Model: Kaiser1 Date: 16-Mar-00 No.: MH306001a

MB Correction

Mainframe (H306)

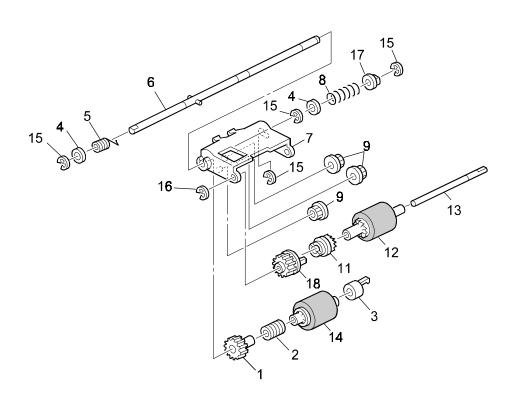
The following are the part numbers for the fusing unit assembly for the Kaiser 1.

Old part	New part	Description	Q'ty	Int	Page	Index	Note
number	number						
-	H3062160	Fusing Unit	1				USA
-	H3062170	Fusing Unit	1				Eur./Asia

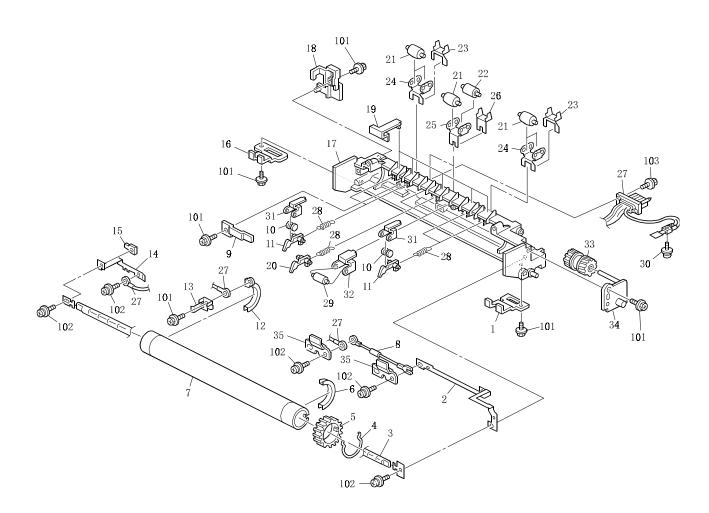
Old part	New part	Description	Q'ty	Int	Page	Index	Note
number	number						
G0294161	H3065068	Thermofuse – 169°C	1	X/O	35	8	
-	G0294133	Cover Screw	2		35	35	*2

- *1: These parts have been used since the first mass production lot.
- *2: This part was not included in the original illustration (not a new part). Please add the index description and illustration.

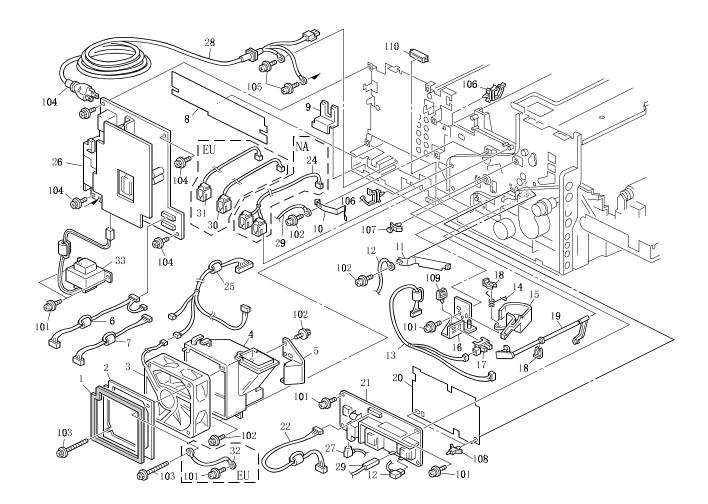
Old part	New part	Description	Q'ty	Int	Page	Index	Note
number	number						
H3065010	H3065011	PSU	1	X/O	41	26	
H3065207	H3065223	Harness NCU-6P	1	X/O	41	30	
H3065212	H3065224	Harness NCU-4P	1	X/O	41	31	
-	N6074525	Choke Coil RITL-9704	1		41	33	*2

- *1: These parts have been used since the first mass production lot.
- *2: This part was not included in the original illustration (not a new part). Please add the index description and illustration.

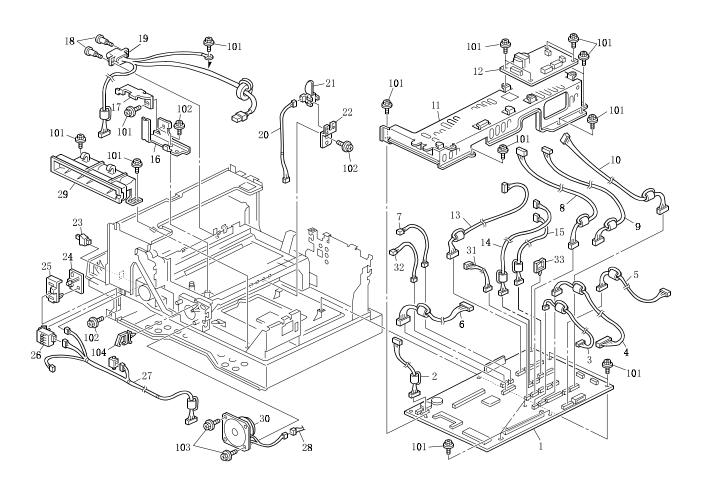
Old part number	New part number	Description	Q'ty	Int	Page	Index	Note
-	H3063198	Clamp	1		43	33	*1

^{*1:} This part was not included in the original illustration (not a new part). Please add the index description and illustration.

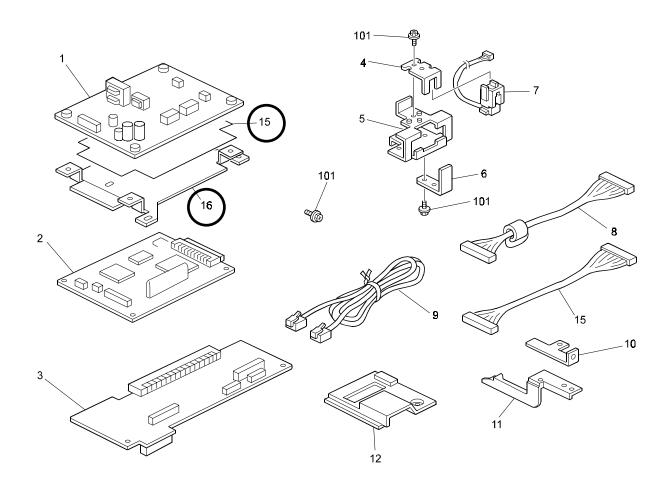
Old part number	New part number	Description	Q'ty	Int	Page	Index	Note
-	54886141	NCU Board – EU/Asia	1		3	1	*1
-	H3064648	Insulation Sheet	1		3	15	*2
	H3064634	Bracket – NCU	1		3	16	*2

Please add in the three index descriptions above along with the illustration for the Insulation Sheet and the NCU Bracket (#15 and 16, circled below).

^{*2:} These parts were not included in the original illustration (not new parts).

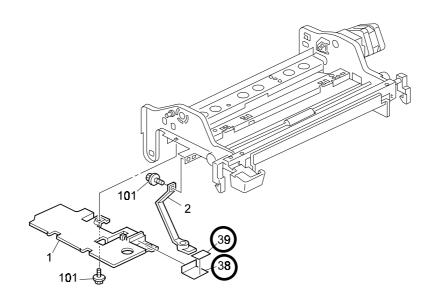
Old part number	New part number	Description	Q'ty	Int	Page	Index	Note
-		Sheet ADF Switch 1	1		13	38	*1
-	H3061335	Sheet ADF Switch 2	1		13	39	*1

^{*1:} This part was not included in the original table or illustration (it is not a new part).

Please add in the two index descriptions above along with the illustration for the Sheet ADF Switch 1 and Sheet ADF Switch 2 (#38 and 39, circled below).

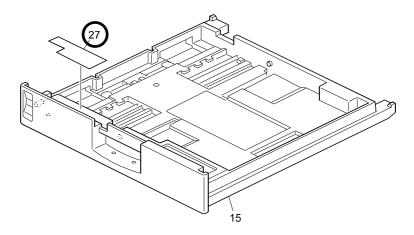
Old part	New part	Description	Q'ty	Int	Page	Index	Note
number	number						
H5235003	AW020075	Photointerrupter	1	X/O	21	5	*1
H3063183	H3062099	Decal – Fusing Cover1	1	O/O	27	7	*2
G0293863	G0293967	Discharge Brush	1	X/O	27	18	*3
H3063129	H3063151	FCU Shield Cover	1	X/O	43	11	*4
G0294175	H3062137	Stripper Pawls	1	O/O	35	20	*2
H3063334	H3063197	Adjusting Screw	1	X/O	45	26	*5
	H3063335	Decal Paper Size	1		29	27	*6

- *1: The old part number was misprinted.
- *2: The new part will be used after the old part is out of stock.
- *3: For the USA, the new part will be used after the old part is out of stock. For Europe/Asia, the new part will be used from the first mass production lot.
- *4: For the USA, the new part has been used since April mass production lot. For Europe/Asia, the new part will be used from the first mass production lot.
- *5: For the USA, the new part has been used since the February mass production lot. For Europe/Asia, the new part will be used from the first mass production lot.
- *6: The new part has been added since the June mass production lot. (see the following illustration)

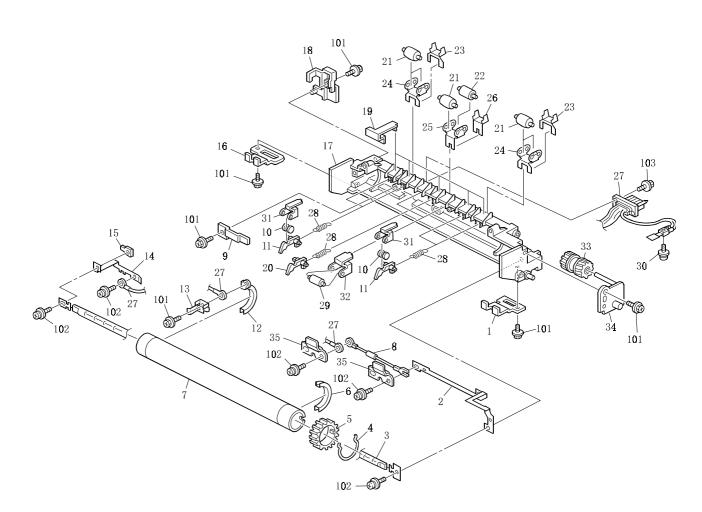
It is possible for the fusing harness cover to become warped due to heat (rare occurrence). To prevent this, its composition has been changed from plastic to metal. Please make the following corrections to your Parts Catalogs.

Old part	New part	Description		Int	Page	Index	Note
number	number						
G029413	3 H3062179	Fusing Harness Cover	1	X/O	34	9
